1998 - 2002 Corvette: Service Bulletin: Audible Spark Knock (Detonation), MIL Illuminated, DTC P0332 Set

Subject: Audible Spark Knock (Detonation), MIL Illuminated, DTC P0332 Set
(Replace Rear Bank Knock Sensor and RTV Area Around Sensor)

Number: 02-06-04-023

Models: 1998-2002 Chevrolet Camaro, Corvette, 1998-2002 Pontiac Firebird with 5.7L Engine (VIN G -- RPO LS1)

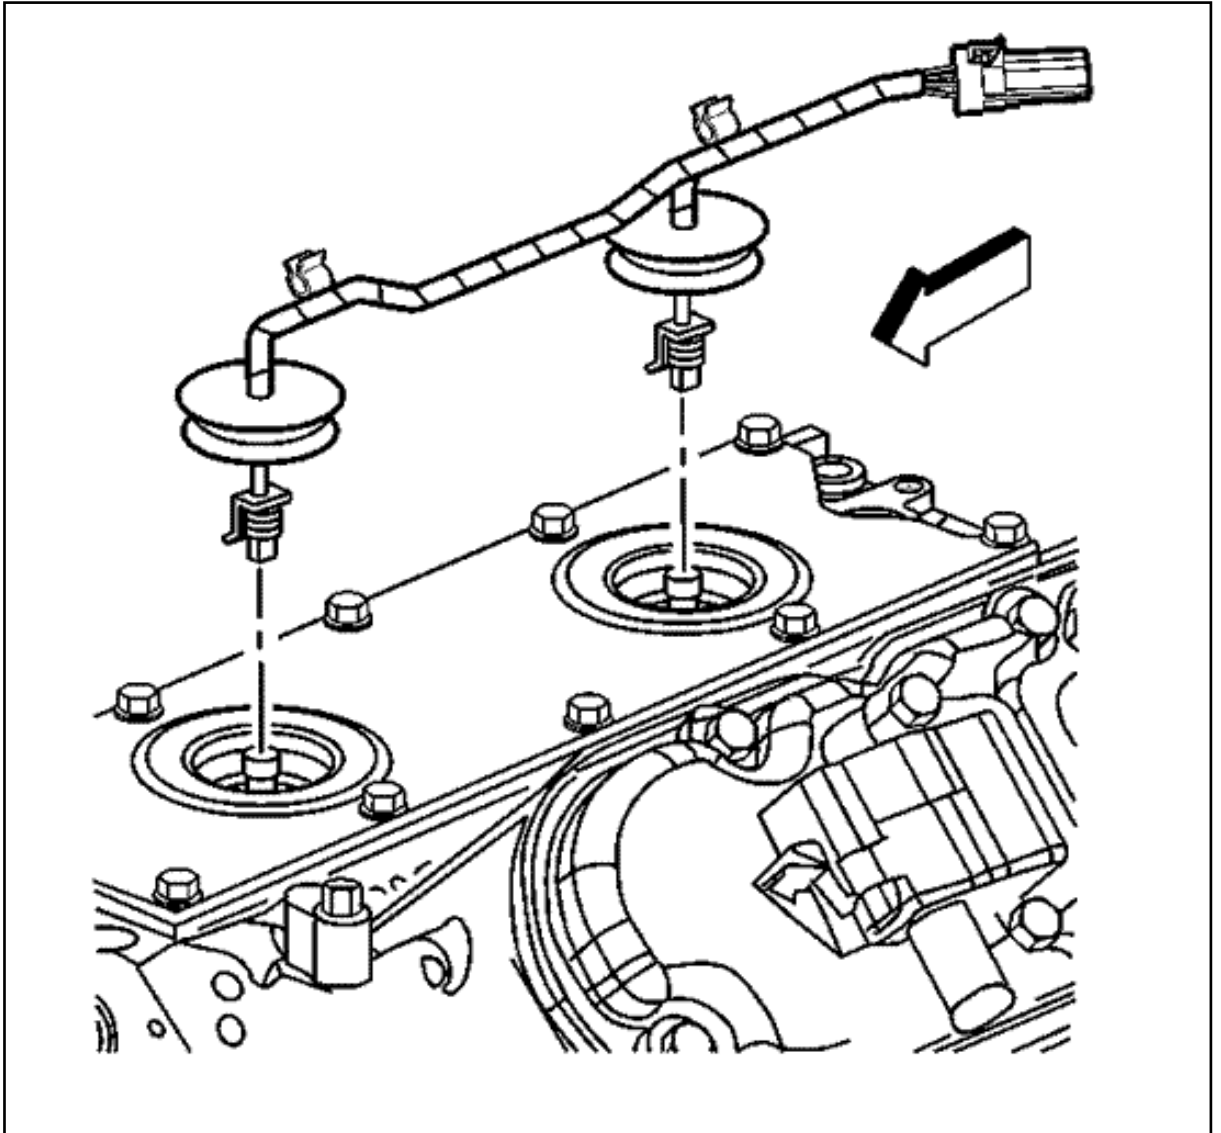
This condition may be the result of corrosion of the rear bank knock sensor due to water intrusion into the sensor cavity. This condition is more apparent on vehicles in which customers frequently wash the engine compartment.

Replace the rear bank knock sensor and build a dam (wall) around the sensor using RTV to divert water away from the sensor. Use the procedure and part number listed below.

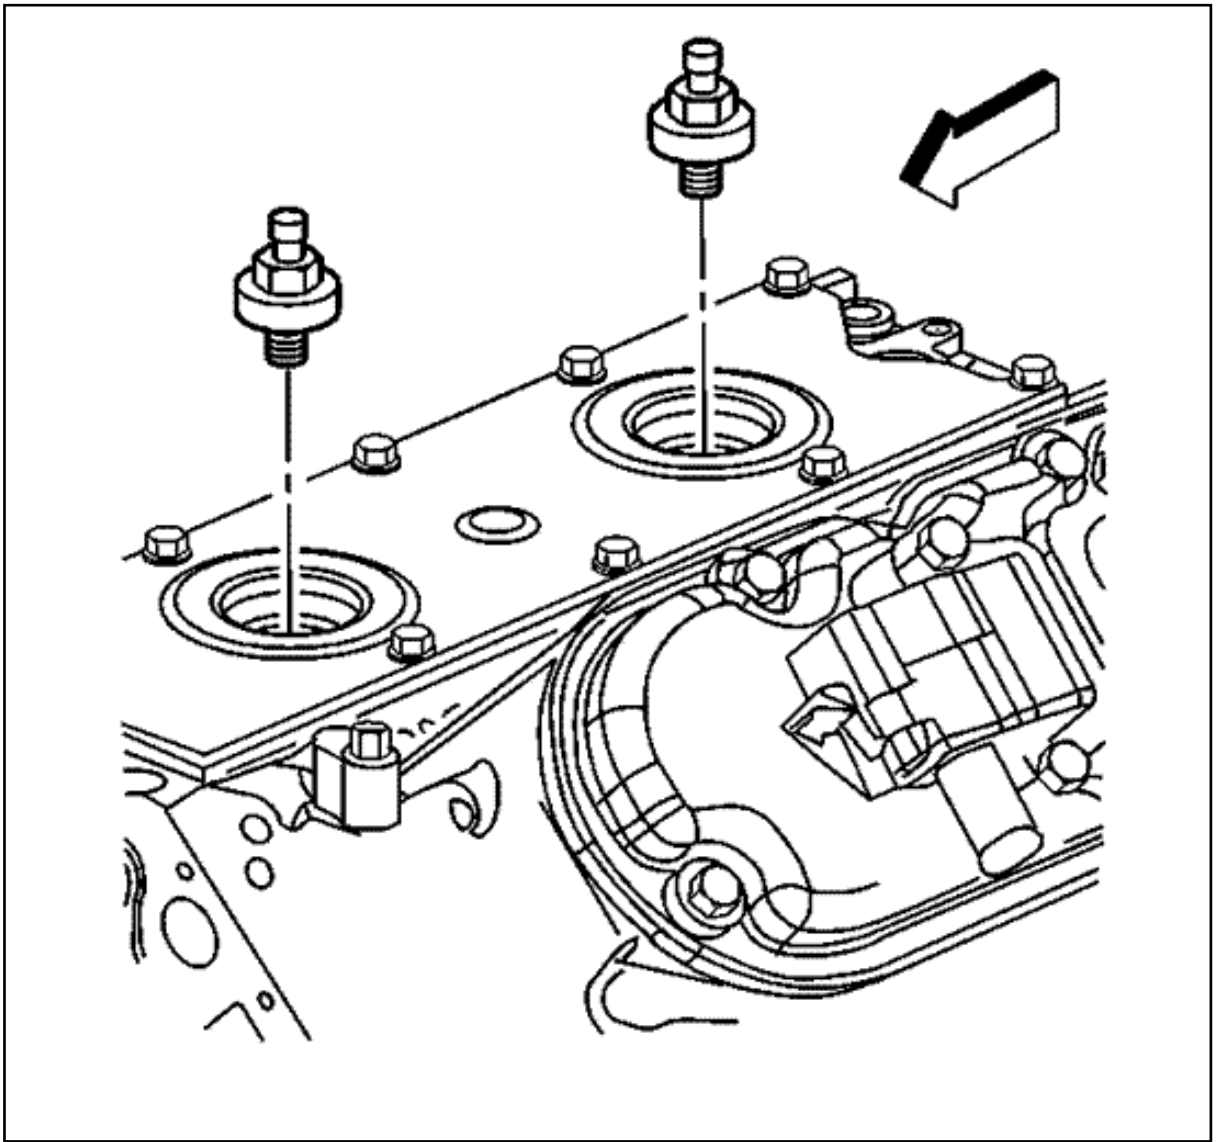
- Remove the wiring harness assembly from the knock sensor.

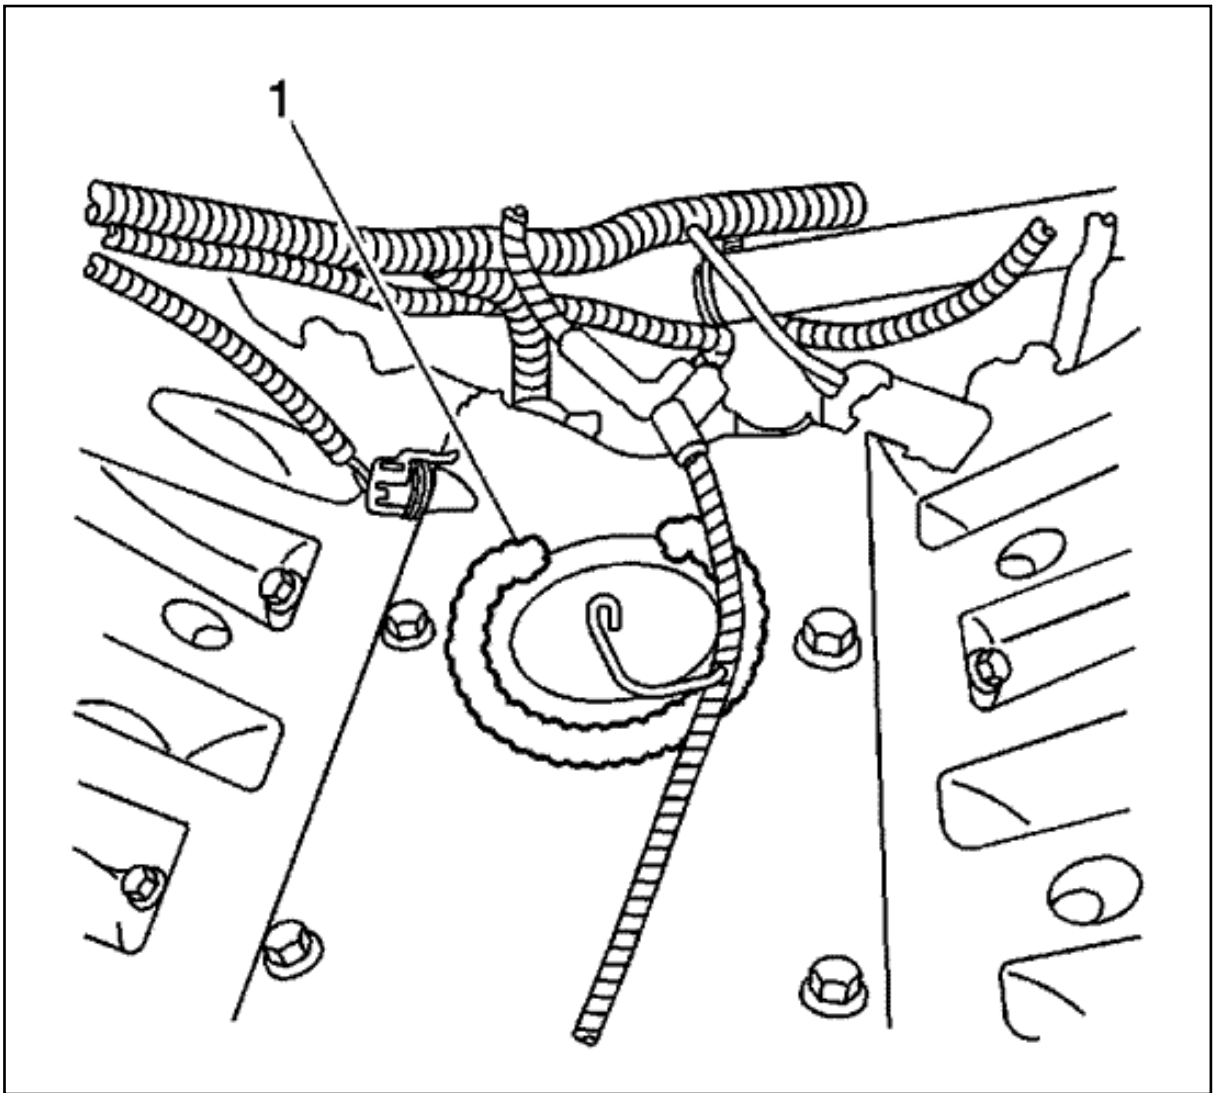
- Remove the rear bank knock sensor.
- Install the new rear bank knock sensor. **Tighten** the knock sensor to 20 N·m(15 lb ft).
- Install the wiring harness assembly to the knock sensor.

- Apply a bead of RTV silicone sealant approximately 9 mm (3/8 in) wide and 6 mm (1/4 in) high along the outside edge of the ridge on the engine block valley cover around the rear bank knock sensor. **DO NOT** form a complete circle. Leave the rear section open as shown.
- From the underside of the intake manifold, completely remove the
